**SUBJECT:** NuScale Power, LLC Response to NRC Request for Additional Information No. 361 (eRAI No. 9285) on the NuScale Design Certification Application

NuScale Response to NRC Request for Additional Information eRAI No. 9285

**NRC Question No.:** 12.03-41

**NRC Question No.:** 12.03-42

Figure 11.4-2b: Solid Radioactive Waste System Diagram  
Air Sparging Operation

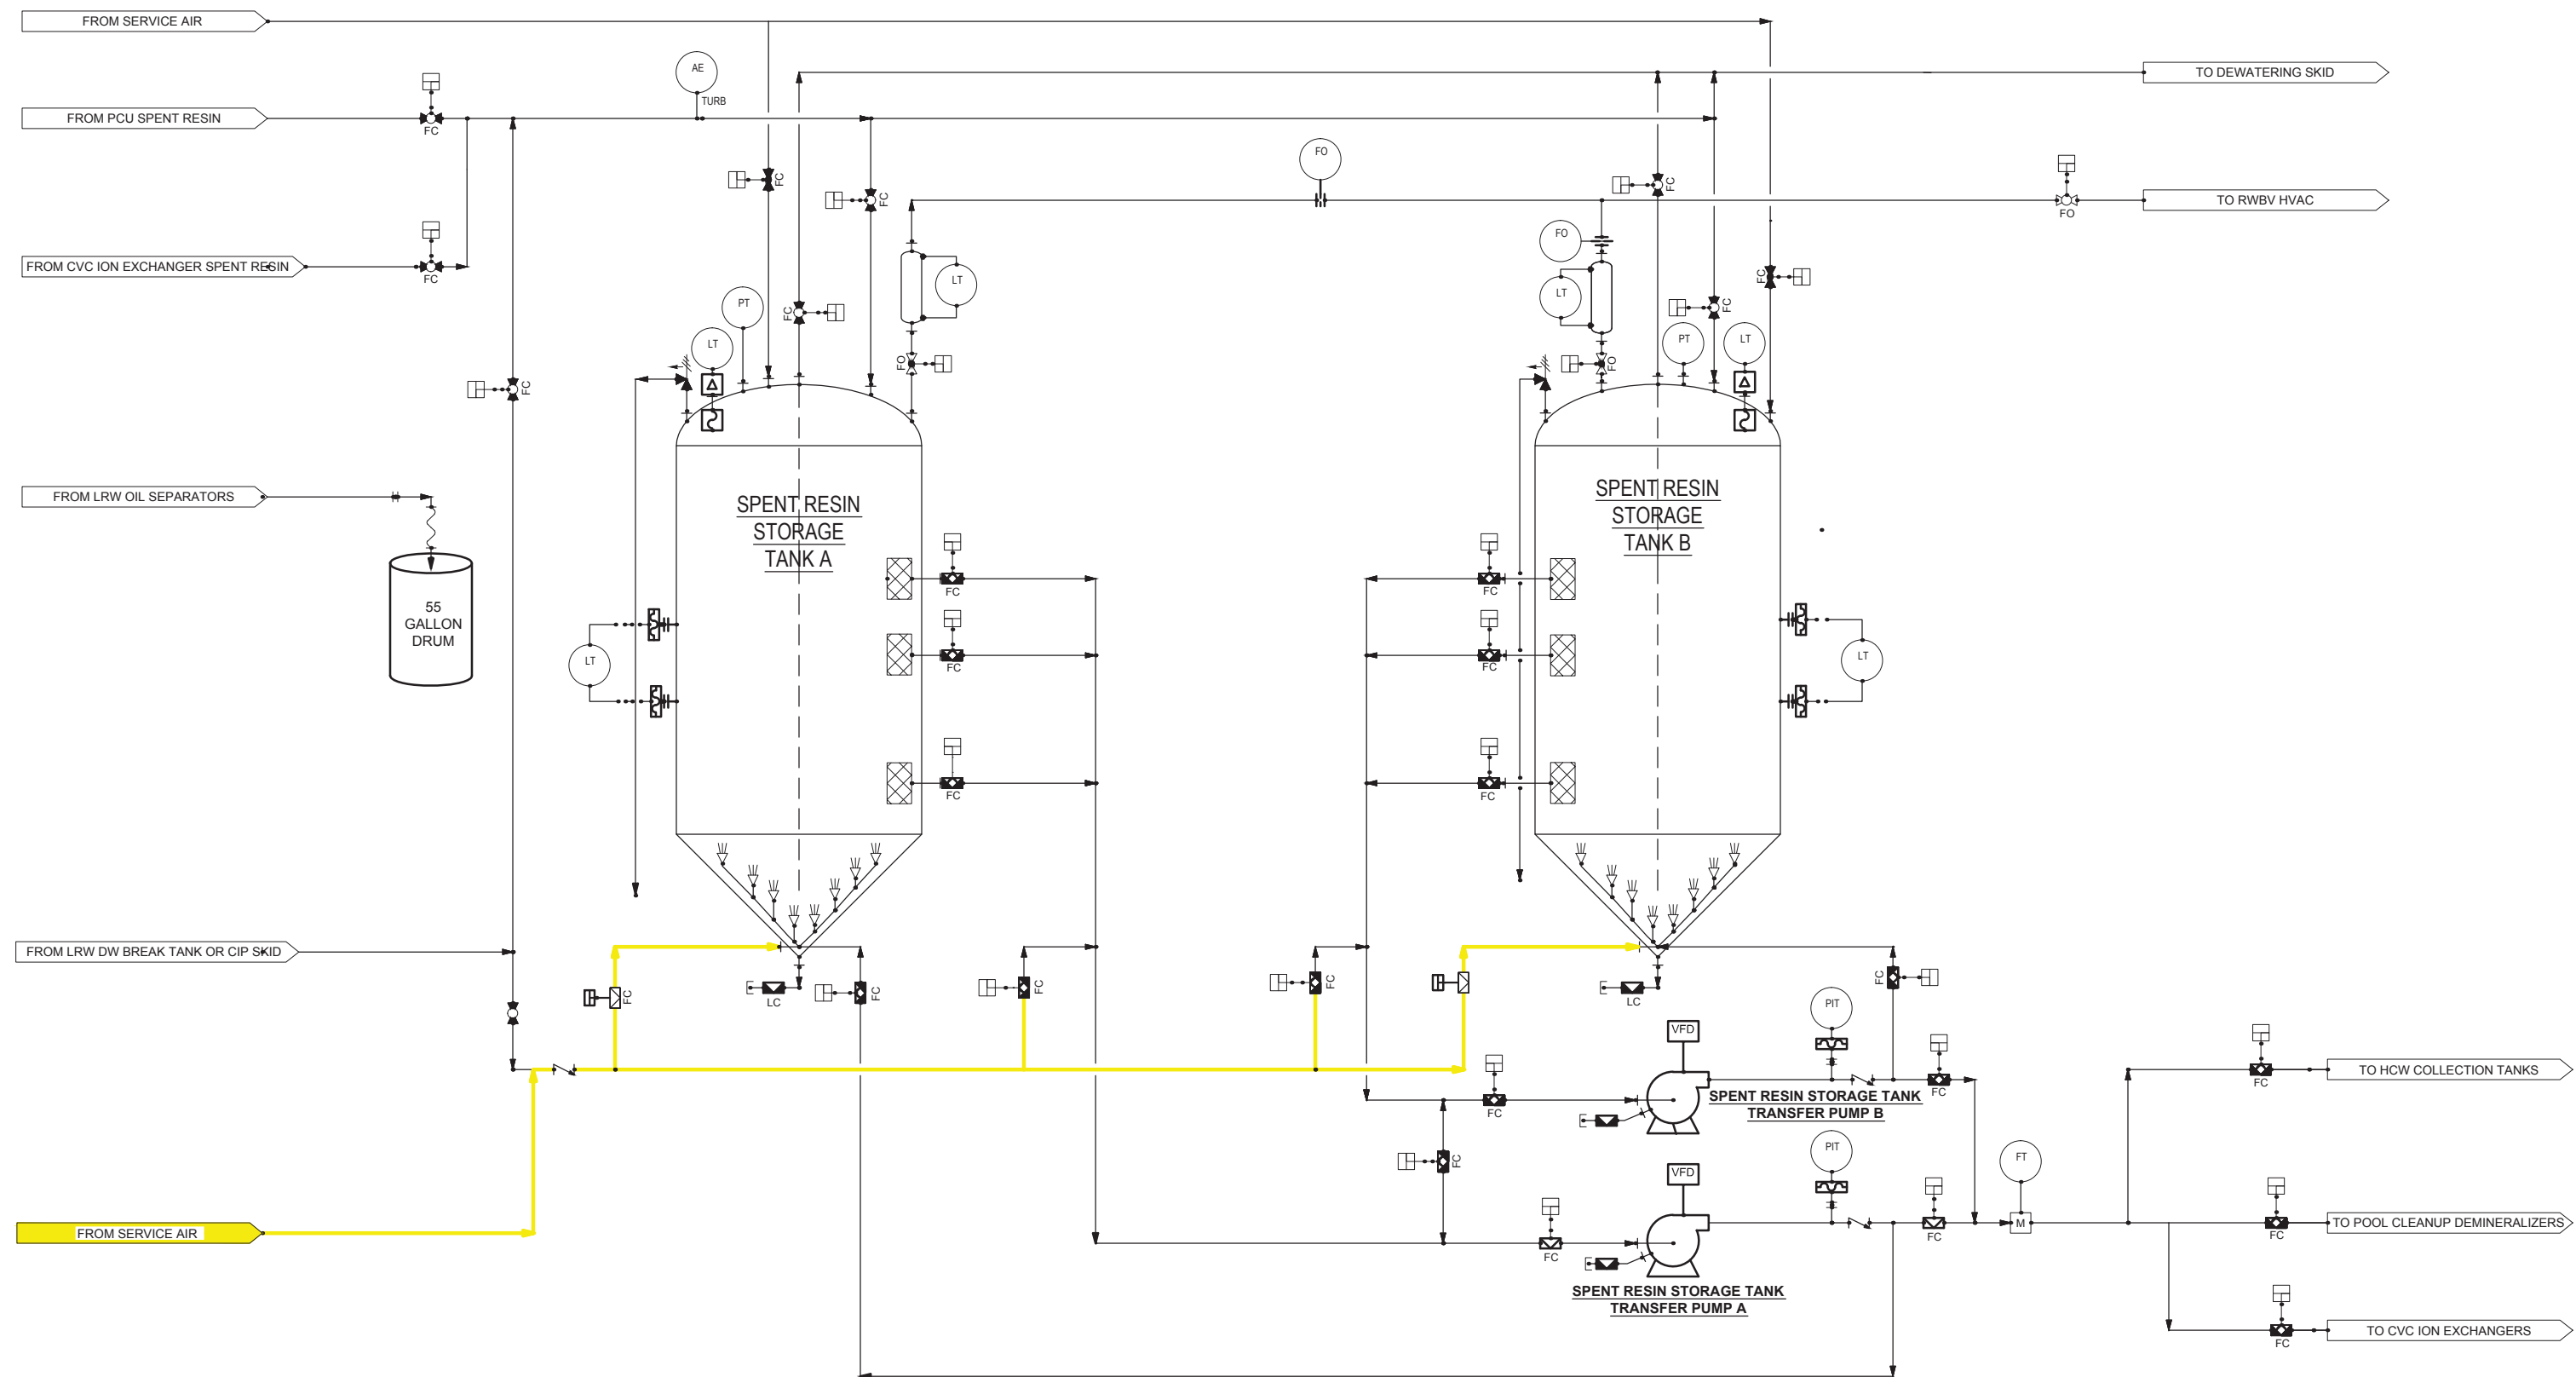
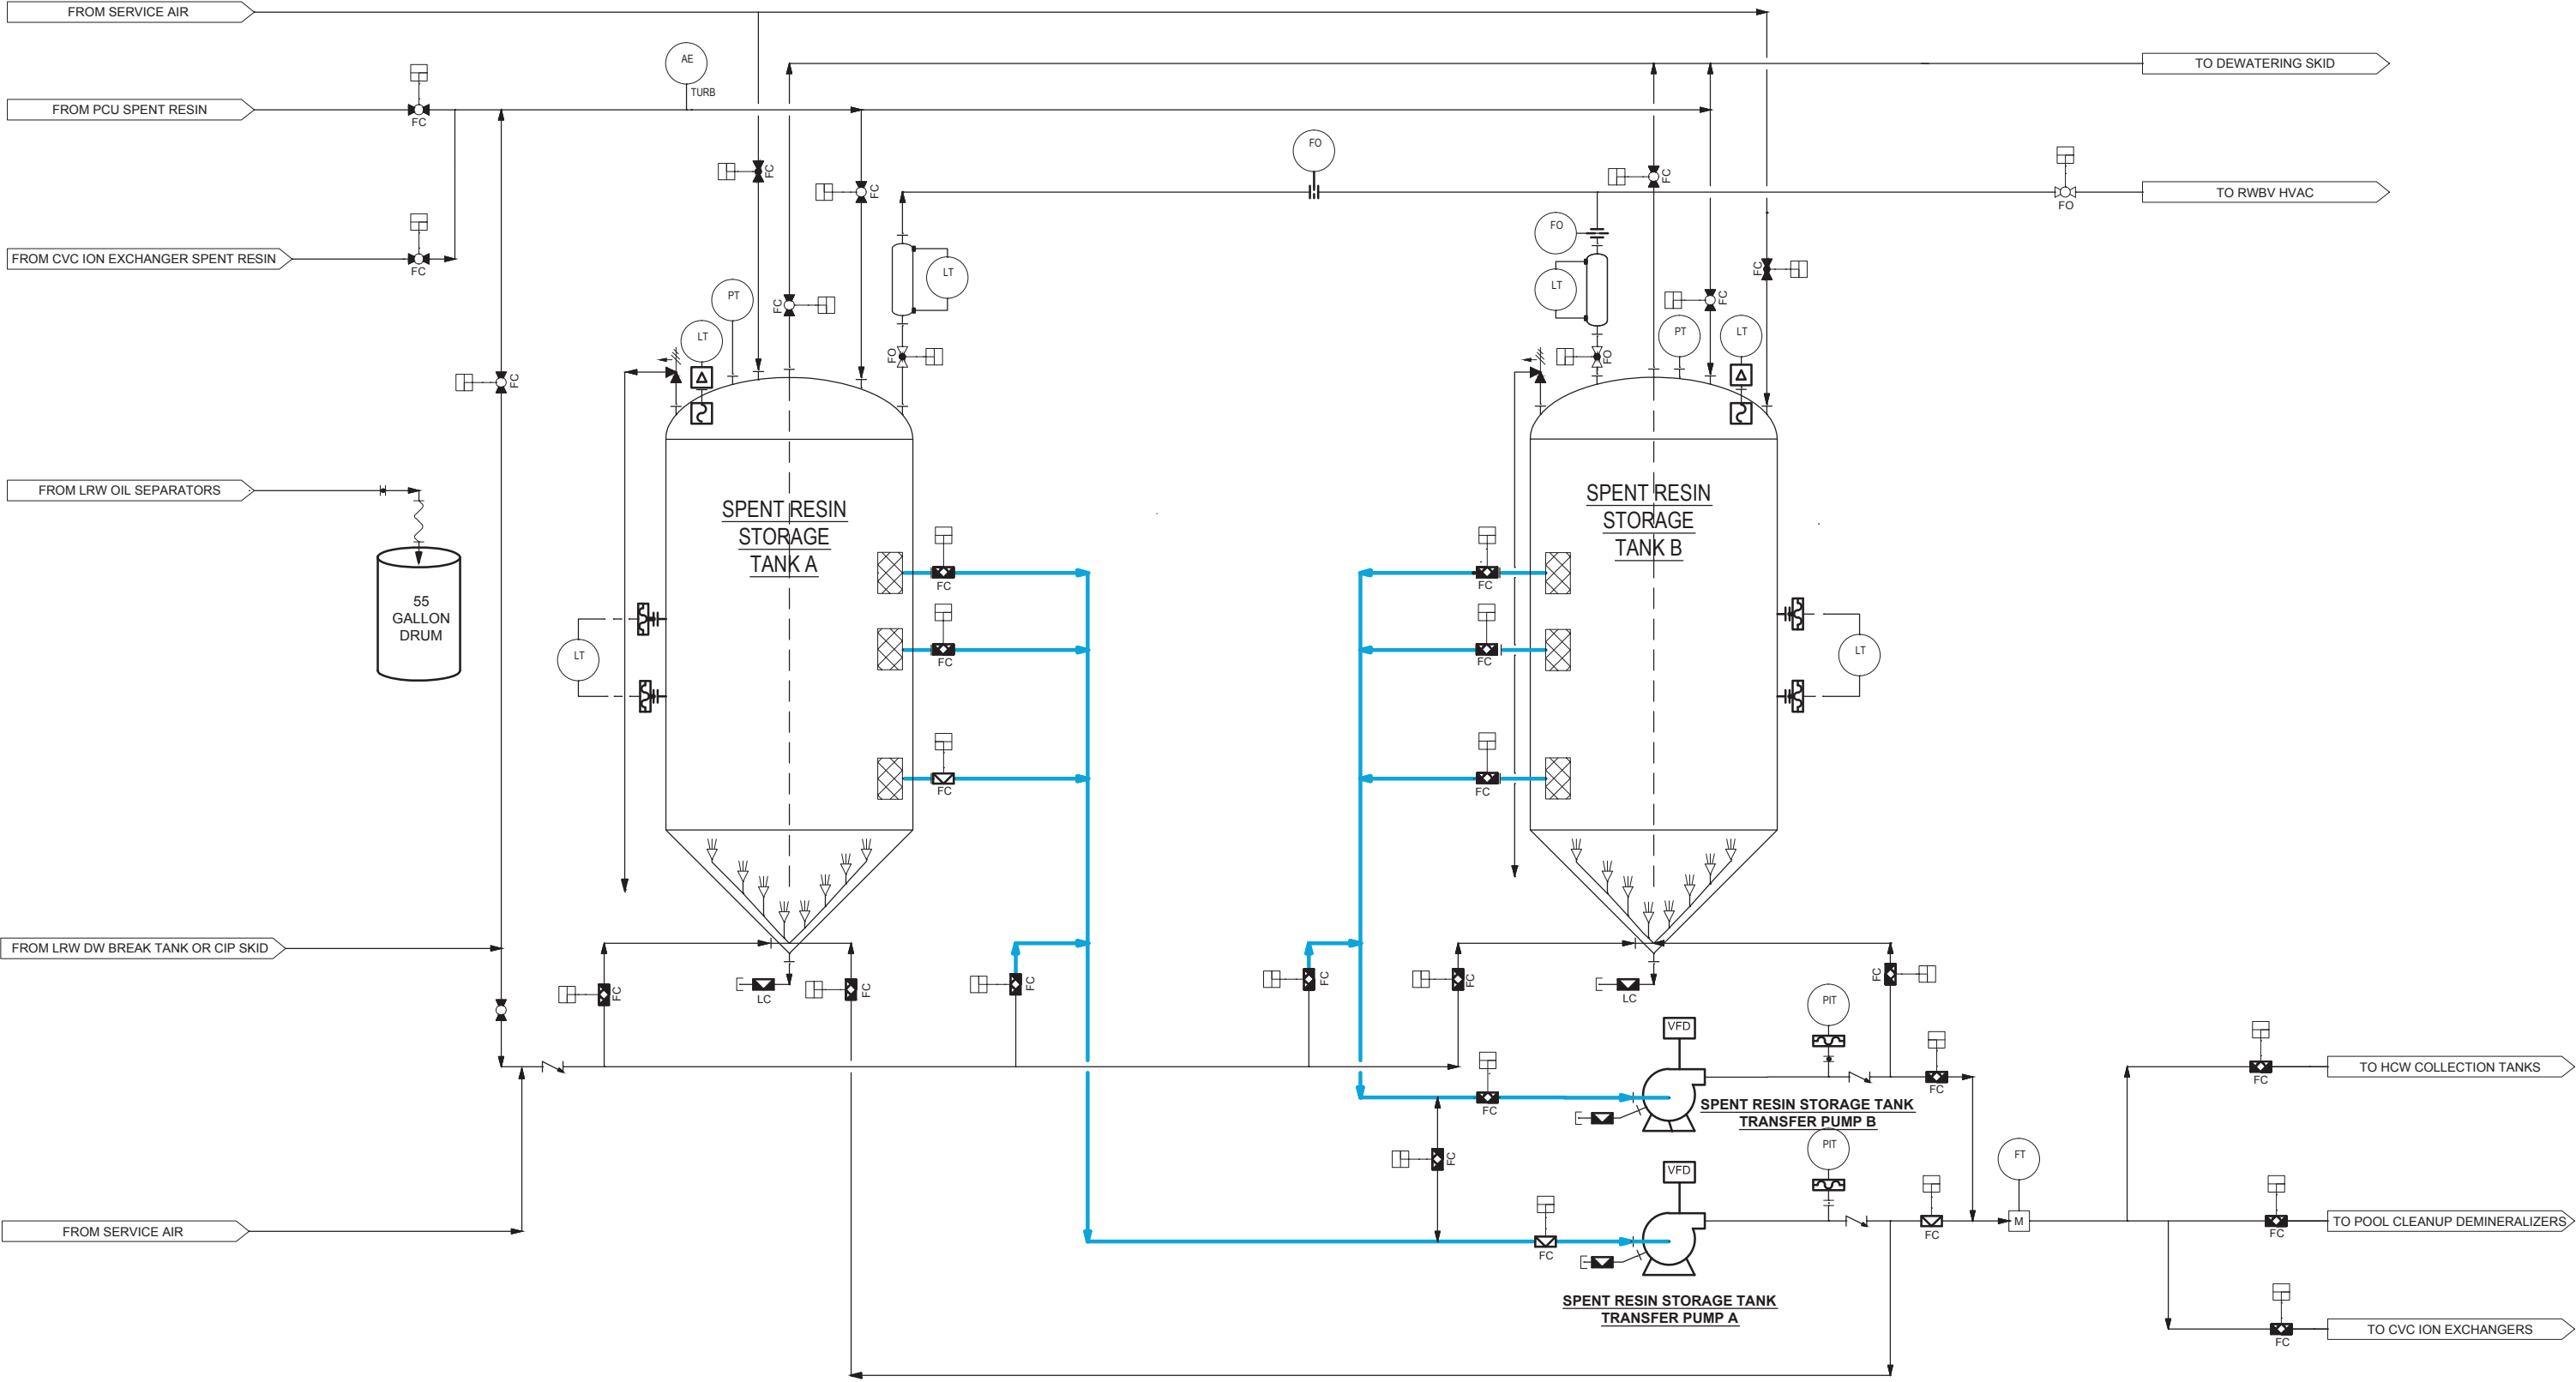
DCD Figure 11.4-2a: “Process Flow Diagram for Wet Solid Waste,” and DCD Figure 11.4-2b:

“Solid Radioactive Waste System Diagram,” show a line from the Service Air system that is separated from the suction of the resin transfer pumps by a single isolation valve. The use of a single isolation valve increases the risk for air intrusion due to valve leakage or misalignment. Based on information made available to the staff during the RPAC Chapter 12 Audit, the suction isolation valves for the pumps appear to be diaphragm disk valves. This information appears to be consistent with DCD Section 11.4.2.5.3, “Piping and Valves,” which states that valves in slurry transfer lines are full-ported ball valves and liquid process valves are diaphragm valves. Operating experience is available (e.g., Electric Power Research Institute (EPRI) Technical Report (TR) 105852 Volume 1 “Valve Application, Maintenance, and Repair Guide,” ) to the staff that indicates that leaks past seats of these types of valves can occur as a result of poor stem travel adjustment, diaphragm age and over setting the stem travel. Typically, these types of valves are not in a periodic performance testing (i.e., leakage testing) program, and the staff has not seen any information that indicates that they are in a performance testing program.

To prevent air intrusion into the SRWS transfer pumps, the service air is isolated from the suction side of the transfer pumps by at least two valves. To illustrate the separation of service air from the transfer pump suction, FSAR Figures 11.4-2a and 11.4-2b are annotated with yellow and blue colored lines to show the system configurations during an air sparging operation and a transfer pump operation.

For the air sparging operation figures, the yellow colored lines indicate the pipes that will be filled with service air during an air sparging operation. It can be seen that there are two isolation valves between the service air and the transfer pump suctions. This mode of operation is expected to be infrequent.

Similarly, for the transfer pump operation figures, the blue colored lines indicate the pipes that will be filled with decant water during a transfer pump operation, and the yellow colored lines still indicate pipes filled with service air. The pump transfer operation figures show there are at least two isolation valves between the service air and the transfer pump suctions.
